SUNDRY NOTICES AND REPORTS ON WELLS

PLUG AND ABANDONMENT PROCEDURE

Apache #15

CONDITIONS OF APPROVAL

Proposed P&A

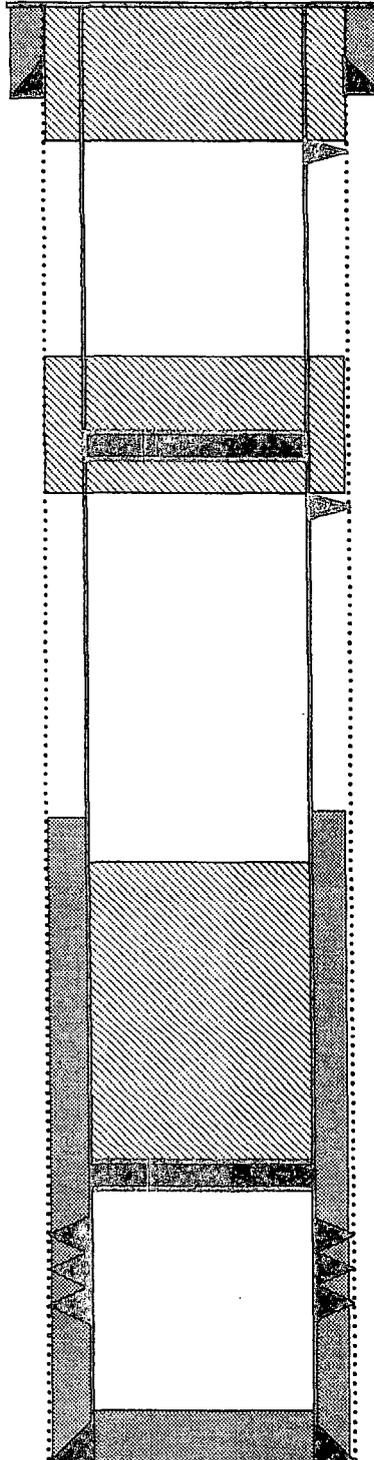
See COA

See COA

1. Plugging operations authorized are subject to the attached "General Requirements for Permanent Abandonment of Wells on Federal and Indian Lease."
2. Farmington Office is to be notified at least 24 hours before the plugging operations commence (505) 564-7750.
3. Bring the top of plug #1 to 2318 ft. to cover the Pictured Cliffs, Fruitland, Kirtland and Ojo Alamo formation tops. Adjust cement volume accordingly
4. Set plug #2 to (976-876) ft. inside/outside to cover the Nacimiento formation top. BLM picks top of Nacimiento at 926 ft.

Operator will run a CBL from 2760 ft., or as deep as possible, to verify cement top. Outside plugs may be revised, based on CBL result. Submit electronic copy of the log for verification to the following BLM and NMOCD address: tsalyers@blm.gov, Brandon.Powell@state.nm.us
